APPROVED
 Limited building only review.
 Permit holder responsible for full compliance with the code.

02/23/2021

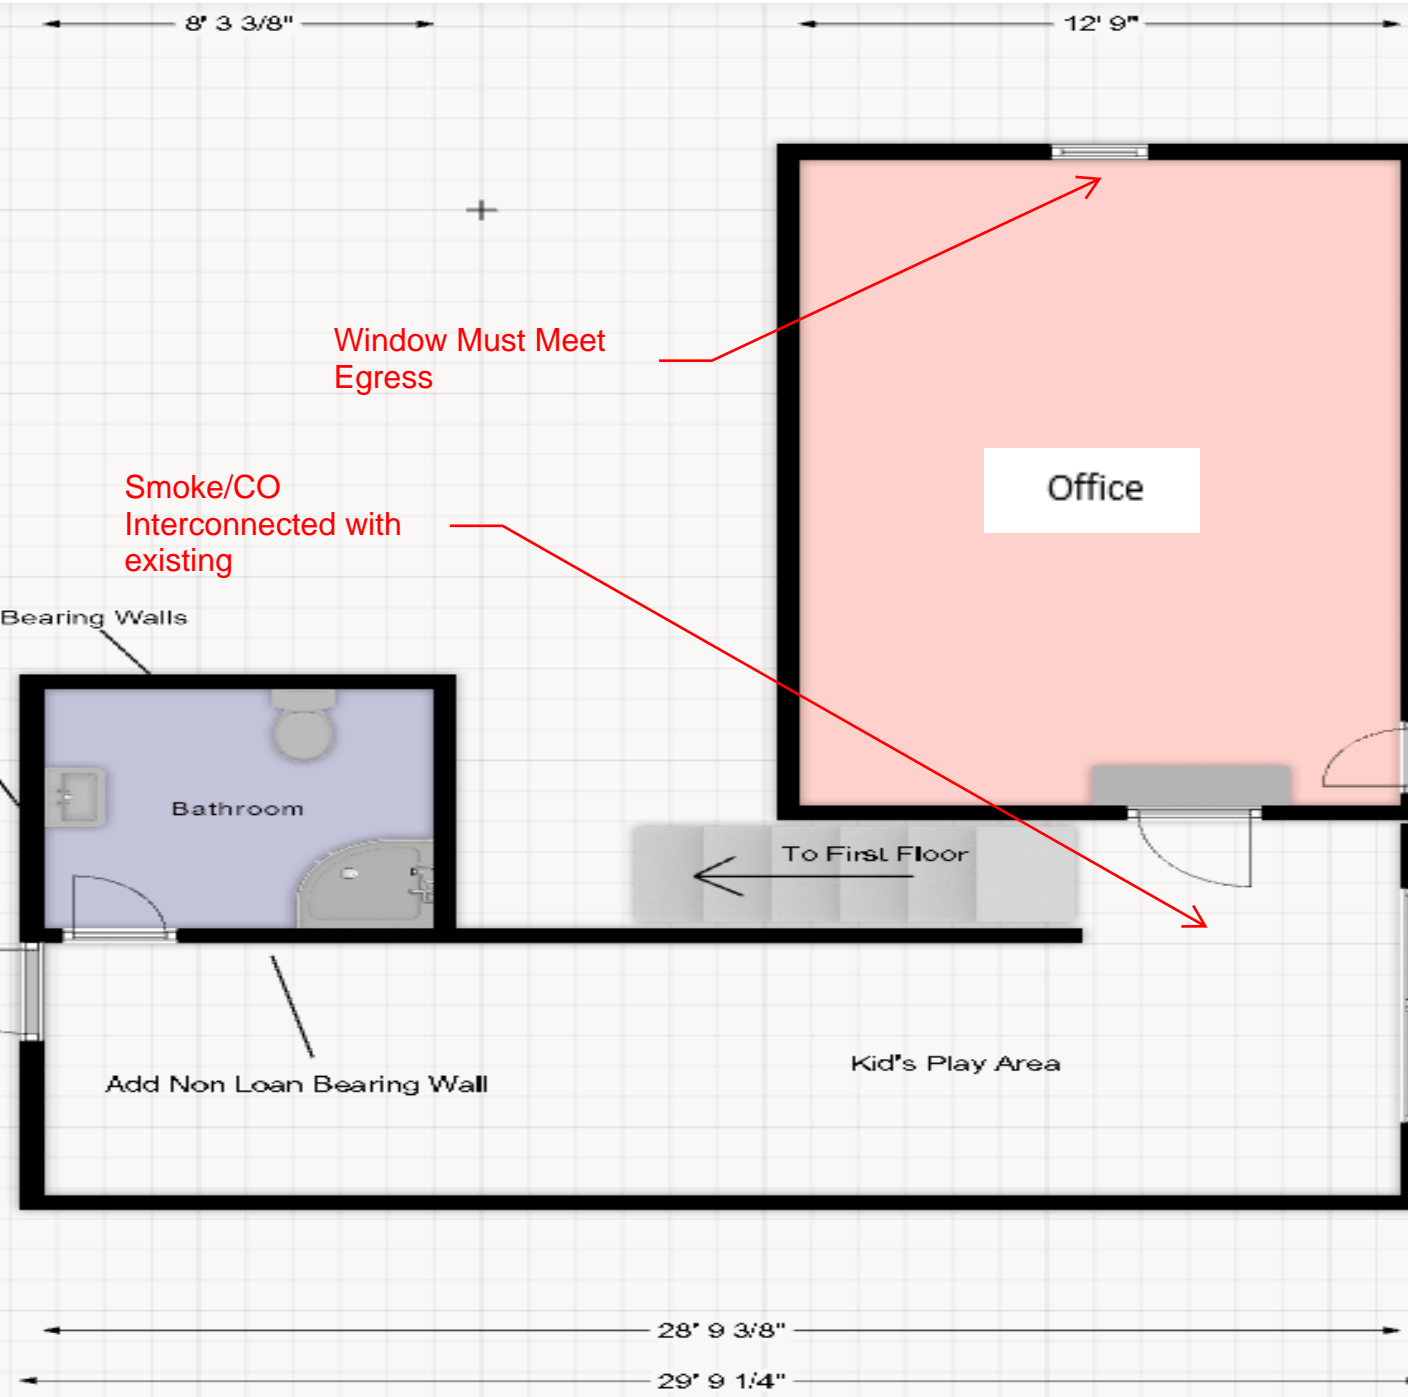
Window Must Meet Egress

Smoke/CO Interconnected with existing

Add Non Load Bearing Walls

Add Non Loan Bearing Wall
